HISTORIC AND DESIGN REVIEW COMMISSION

May 01, 2024

HDRC CASE NO: 2024-155
ADDRESS: 2100 BROADWAY
LEGAL DESCRIPTION: NCB 1763 BLK 33 LOT 1-4, 7-12, P-100-103 & P-105 -106 (PORTION OF CLOSED ALLEY)1
ZONING: IDZ, RIO-1, NCD-9
CITY COUNCIL DIST.: 2
APPLICANT: Ariel Vega/PDI
OWNER: 4M BROADWAY LLC
TYPE OF WORK: Construction of commercial structures and a sub-grade parking structure
APPLICATION RECEIVED: April 12, 2024
60-DAY REVIEW: June 11, 2024
CASE MANAGER: Edward Hall

The applicant is requesting conceptual approval to construct a multi-component restaurant development on the vacant lot at 2100 Broadway, located within RIO-1. The proposed construction will feature a restaurant structure, a dining courtyard, a pit house and a sub-grade parking structure with a vertical circulation component at the corner of Broadway and Alling.

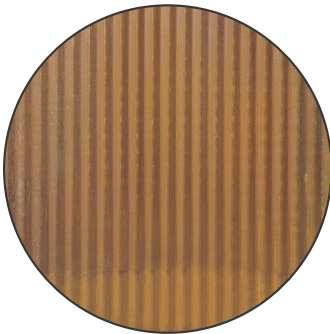
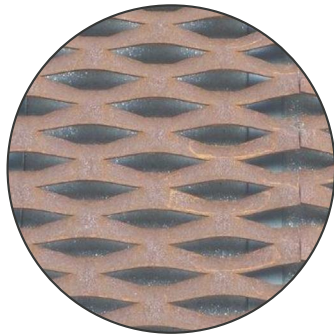
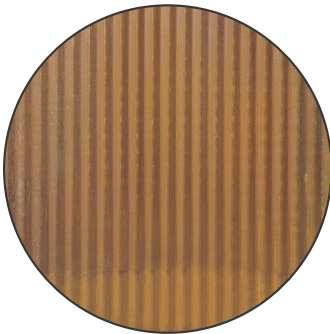
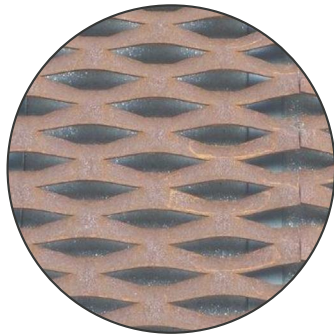
- p. **ARCHITECTURAL FOCAL POINT** – The UDC Section 35-672(c)(1), notes that an architectural focal point is to be incorporated into the design when a property is situated in such a manner as to appear as the terminus at the end of the street. An architectural feature will be considered to be a focal point through any of the following methods, but not limited to: additional height, creation of a tower, variation in roof shape, change of color or materials or the addition of a design enhancement feature. At the corner of Broadway and Alling, the applicant has proposed to construct a pedestrian circulation element to feature corten steel siding, a corrugated metal roof, and corten mesh screening.

JV: Questions about materials, specifically metal materials. Finds rusted corten to be too harsh for context with other materials. Find inspiration from existing buildings.

Pedestrian Safety features at Parking Garage Entry

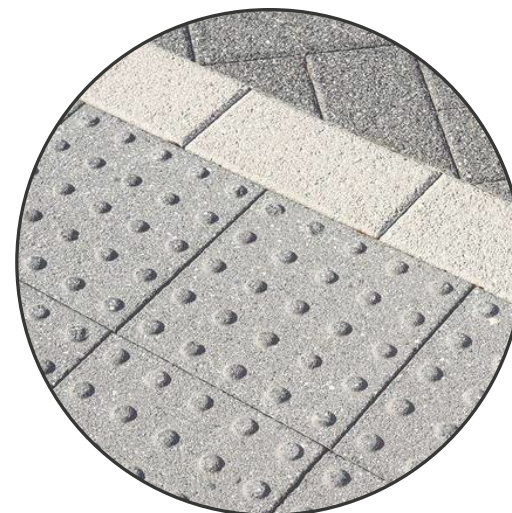
LG: Questions regarding curb cuts, sub-grade parking and if parking will be provided for the public.

- We are proposing a 10% speed ramp into the garage, and not maxing out the speed ramp (16%), thus creating better sight lines.
- Ability to shift the ramp further toward the east (into the garage) to create more flat driving surface prior to the sidewalk.
- Change in paving pattern
- “Truncated Domes” strip as pedestrian warning device
- Vehicle warning devices
 - Caution Car Coming” sign
 - Audible Alarms
- Convex Mirrors
